ARCHITECTURAL REVIEW BOARD MEETING

TO: Planning and Zoning Commission
DATE: September 26, 2023
APPLICANT: Scott Lewis; *Scott Lewis Homes*
CASE NUMBER: SP2023-031; *Amended Site Plan for 3301 Springer Road*

PROJECT NUMBER: SP2023-031
PROJECT NAME: Amended Site Plan for 3301 Springer Drive
SITE ADDRESS/LOCATIONS: 3301 SPRINGER RD

PROJECT NUMBER: SP2023-032
PROJECT NAME: Site Plan for 855 Whitmore Drive
SITE ADDRESS/LOCATIONS: 855 WHITMORE DR

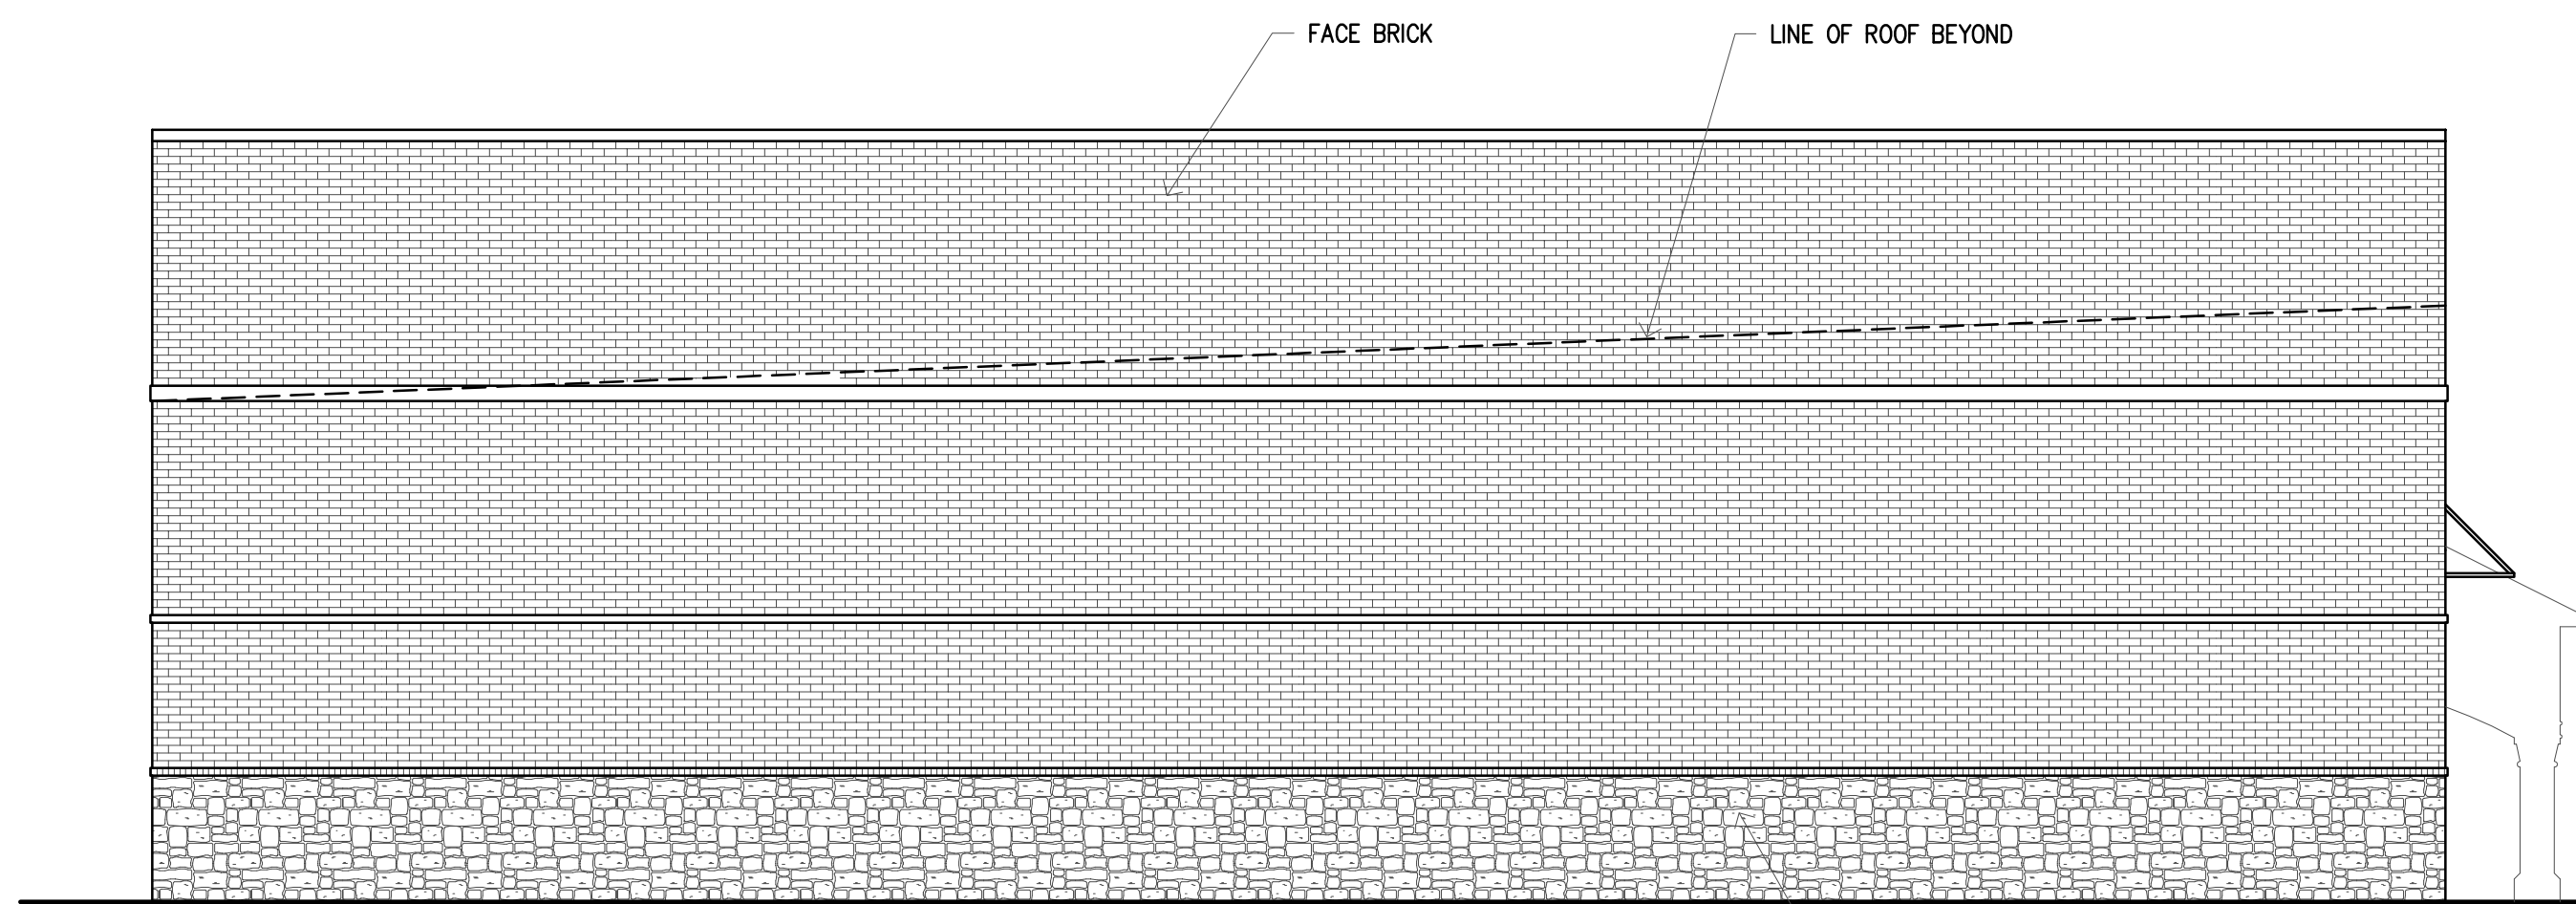
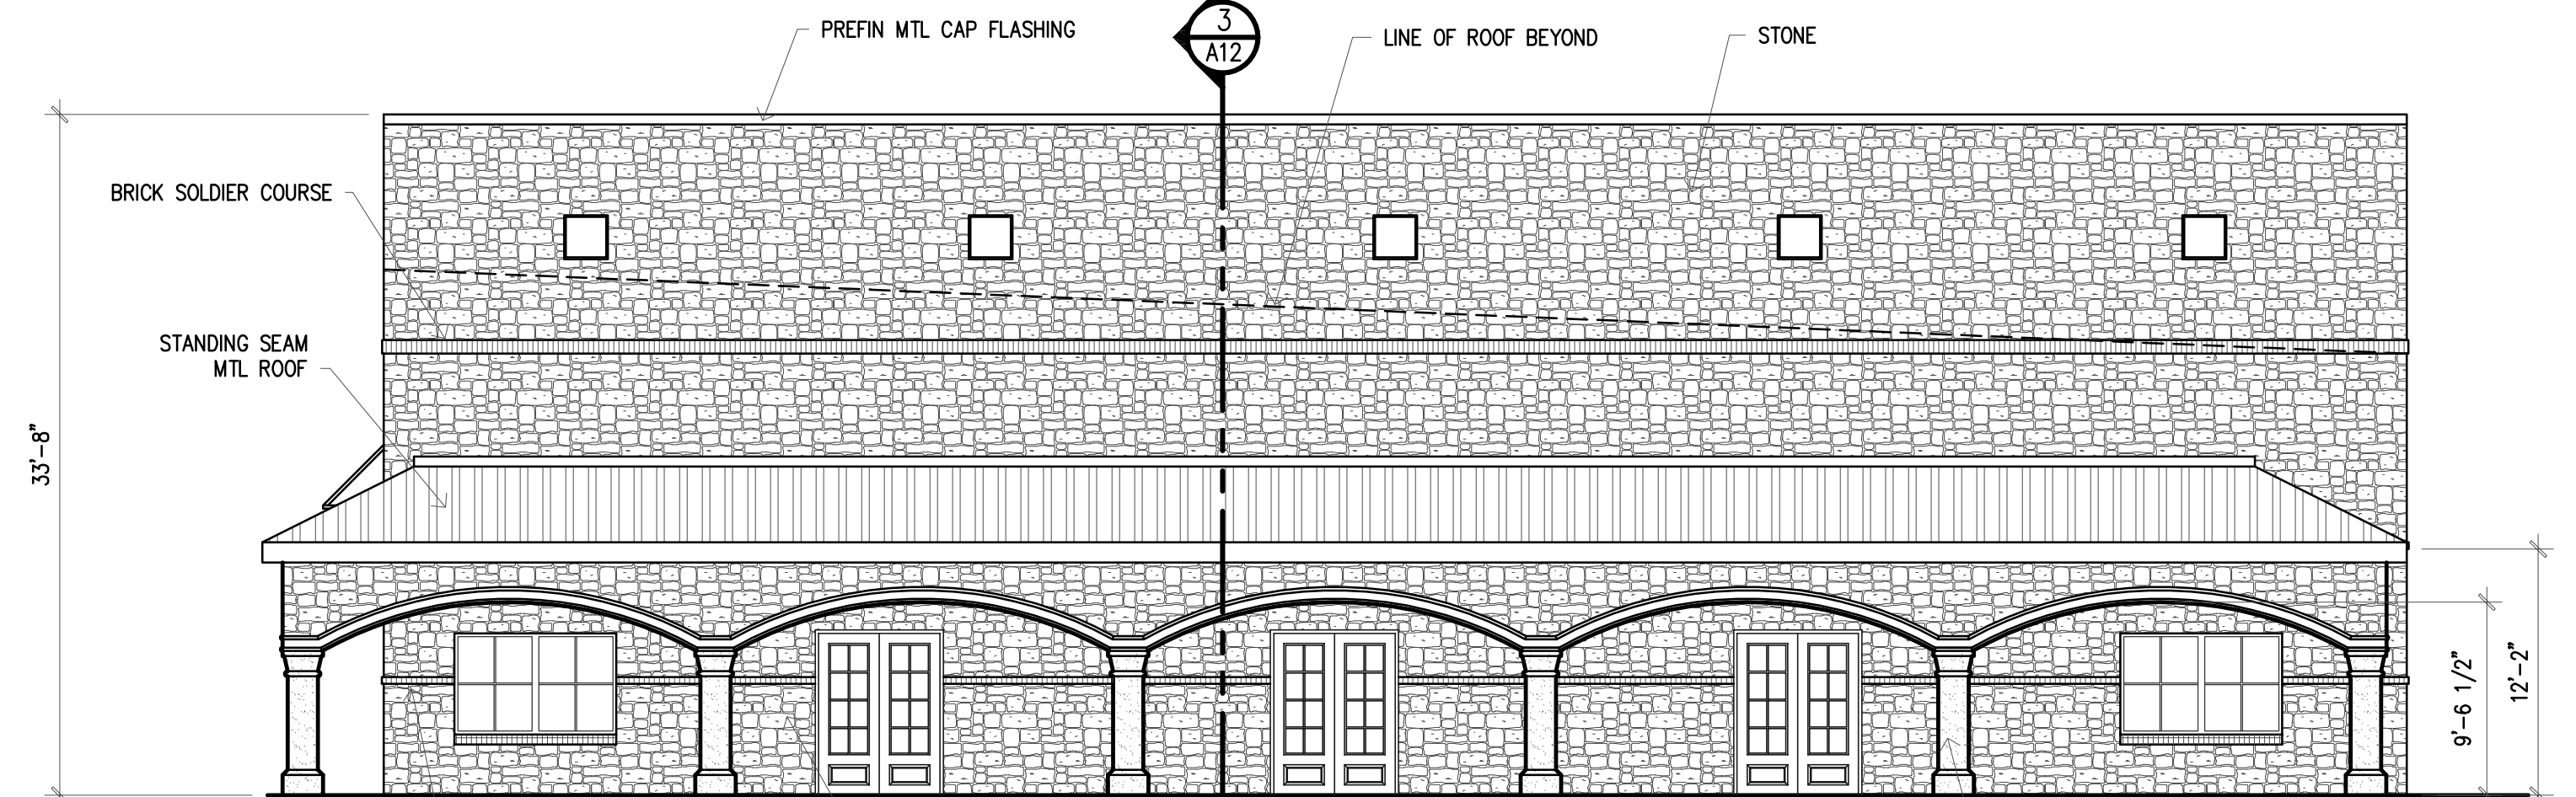
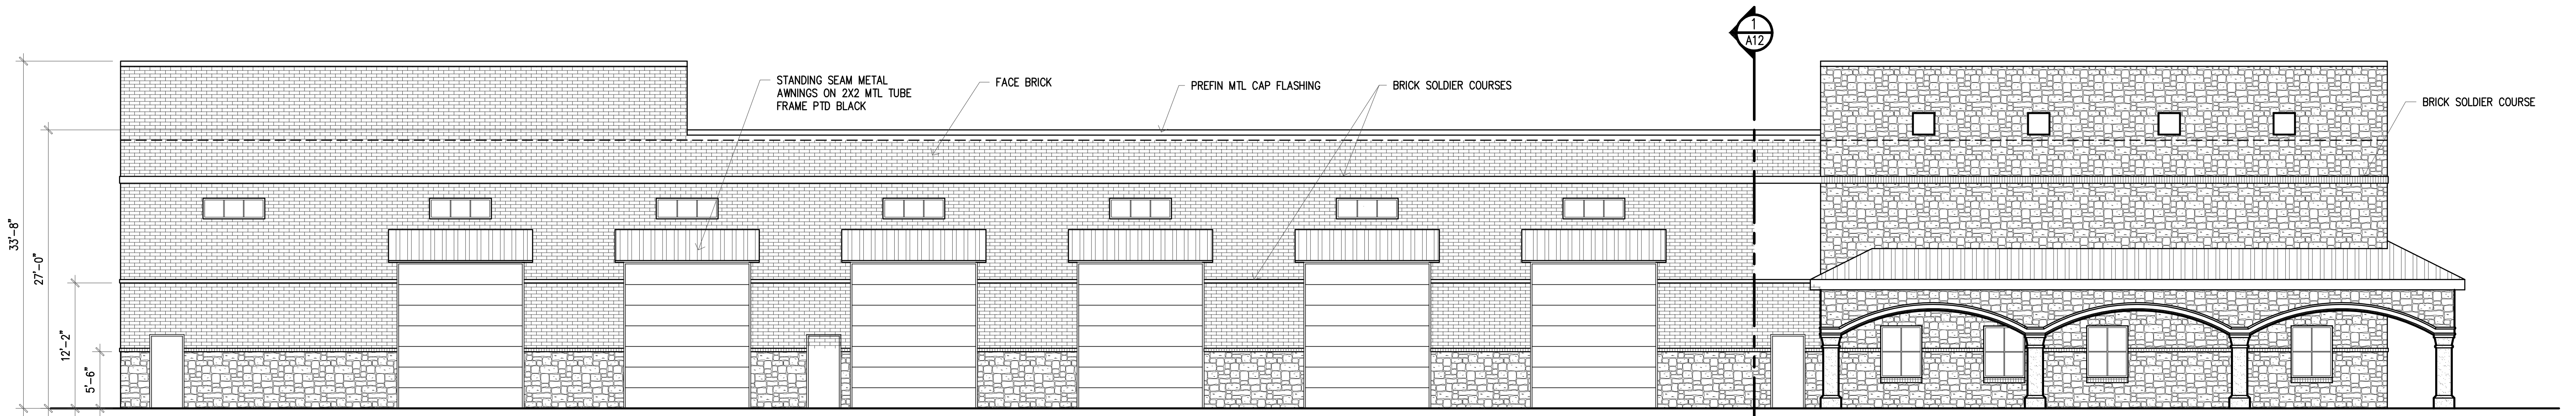
1) The parapet is required to be finished on both sides with the same material as the external facing façade. In this case, the parapet must be finished on both sides with the proposed brick. Given this, please provide a note indicating this requirement. (Subsection 03.04(A) of Article 11, UDC)

SITE PLAN

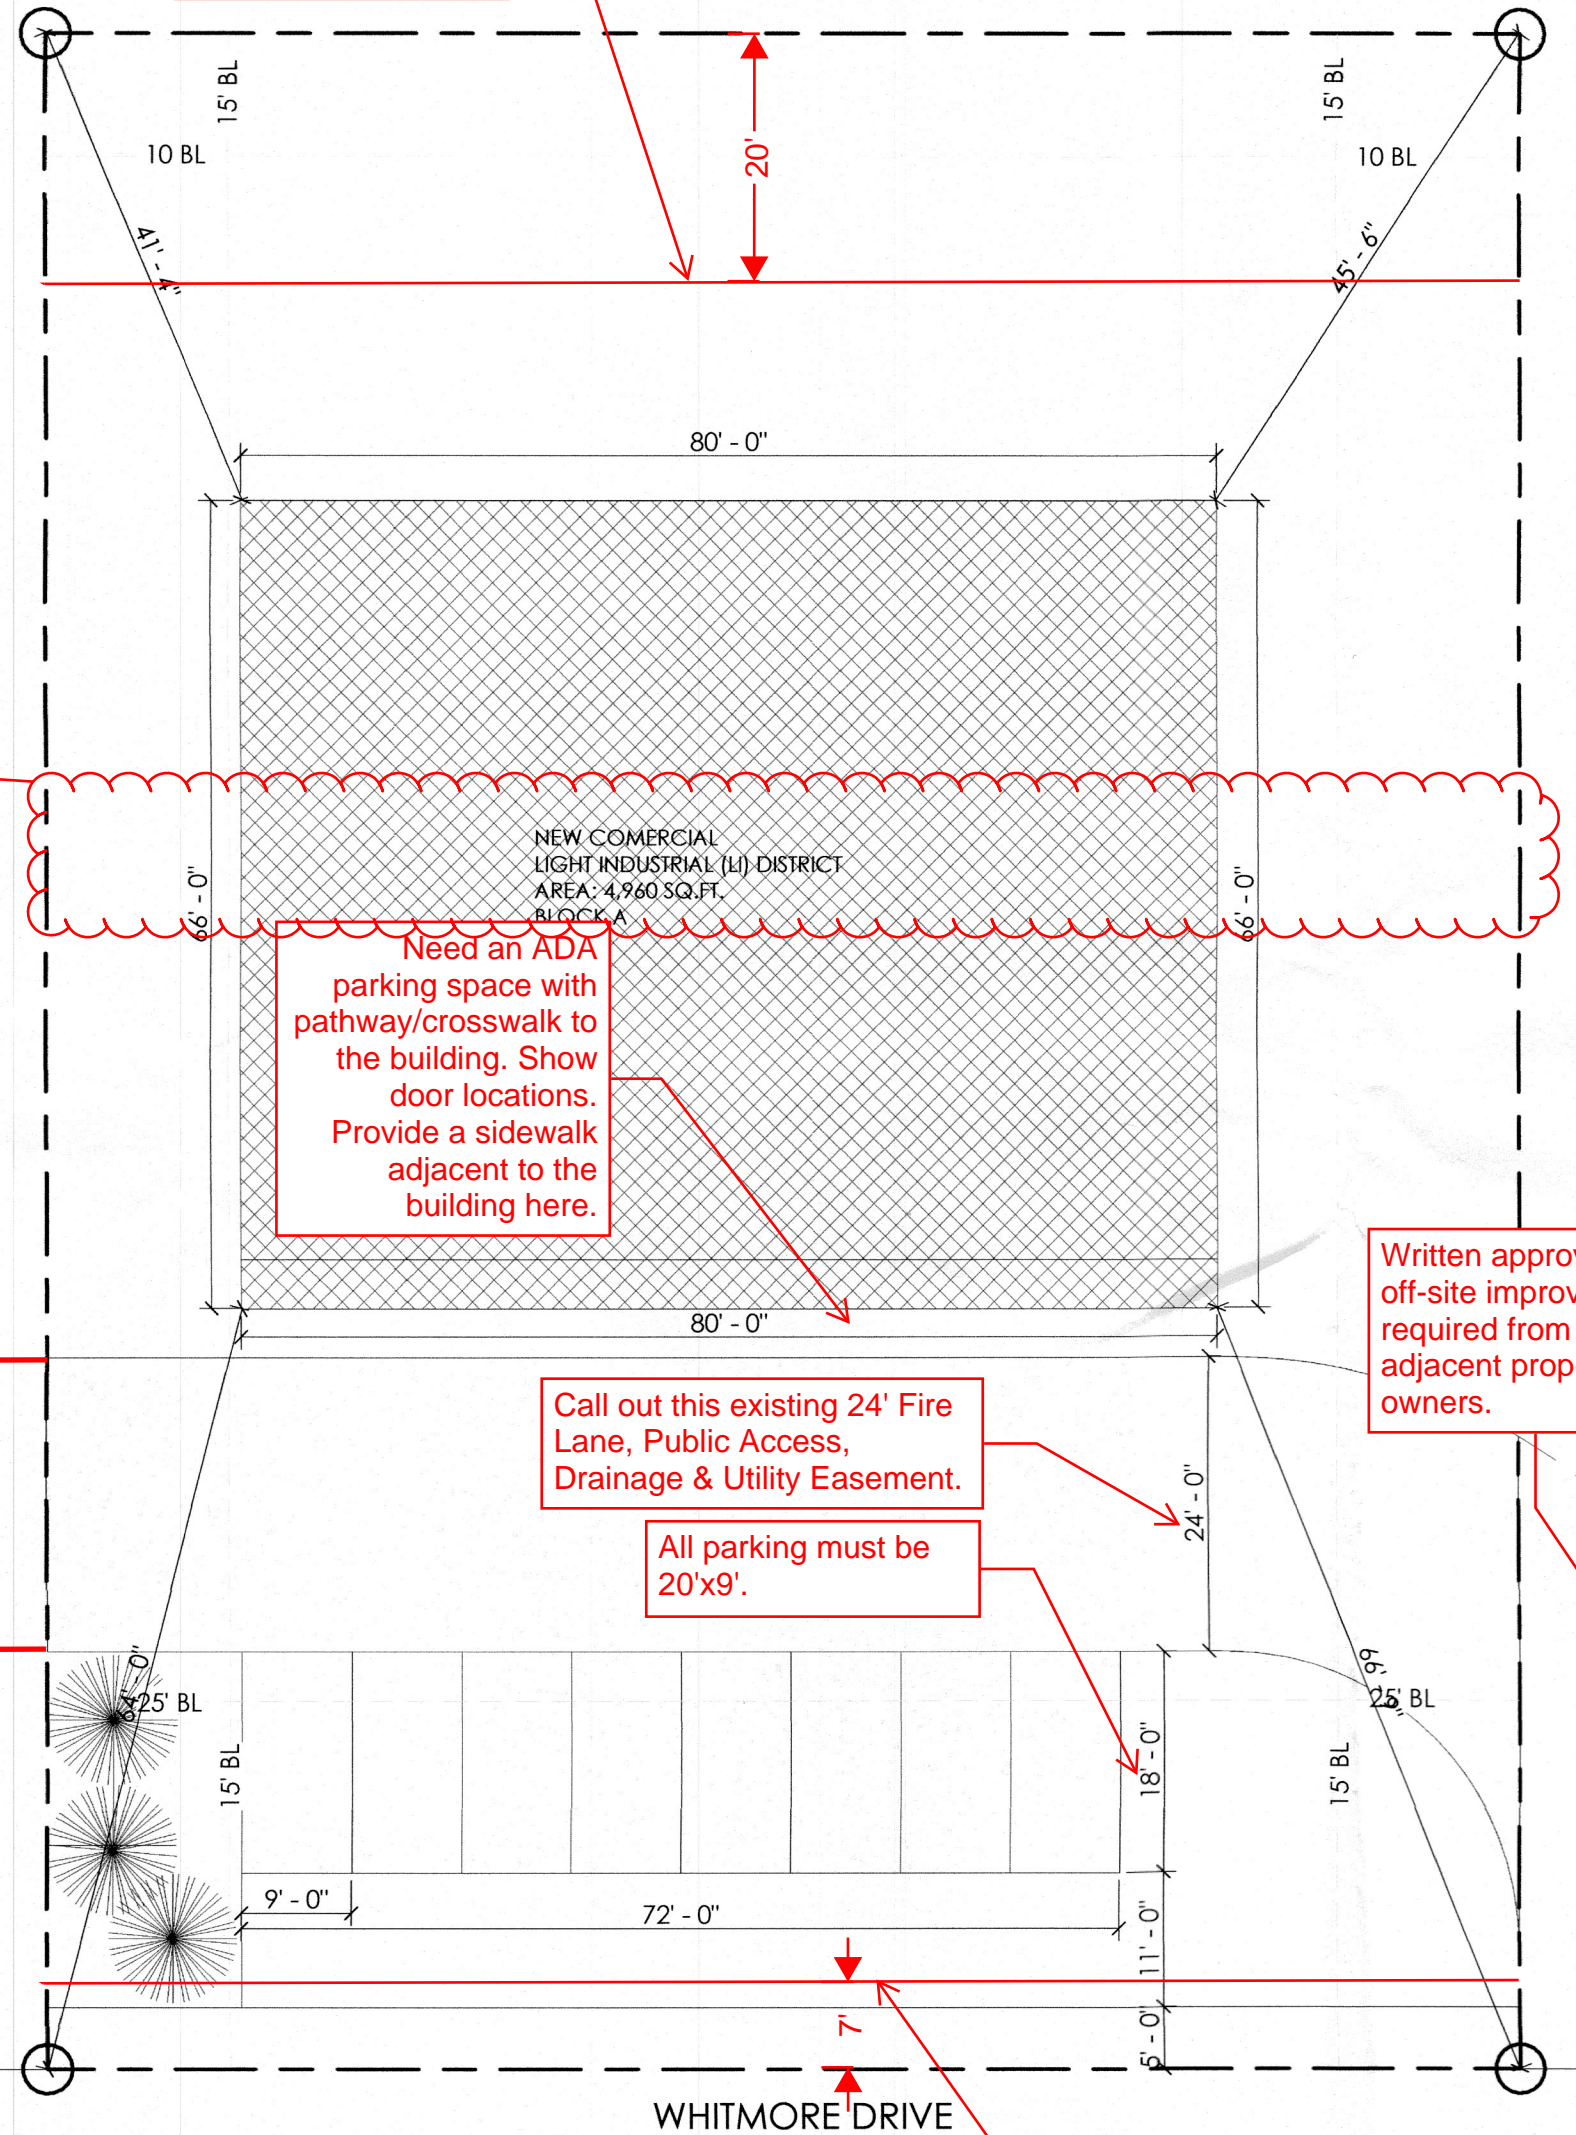
Plat shows an existing 20' drainage easement along the back of the property. Please show.

Adjacent property must relocate dumpster out of easement/path.

Need an ADA parking space with pathway/crosswalk to the building. Show door locations. Provide a sidewalk adjacent to the building here.

- Drainage Items:**
- Add note that the property owner will be responsible for maintaining, repair, and replacement of the detention/drainage systems.
 - No grate inlets allowed
 - Dumpster areas/pads must drain to an oil/water separator.
 - Ex. detention system volume and outfall will need to be for capacity and elevation.

- Water and Wastewater Items:**
- Show existing/proposed utility lines (Water, Sewer, etc.)
 - Public sewer to be 8" minimum.
 - Any water lines must be a minimum of 8", looped, and must be in a 20' wide easement. (Meet City of Rockwall Standards of Design and Construction)
 - Only one "use" off a dead-end line (domestic, irrigation, fire sprinkler, fire hydrant, etc.)
 - Min 20' utility easements. Easement width based on size of line and depth.
 - Required to show ex. and proposed water and sewer on site plan.
 - Sanitary sewer service must be connected to a manhole.
 - Sewer service crossing of Whitmore must be by bore.
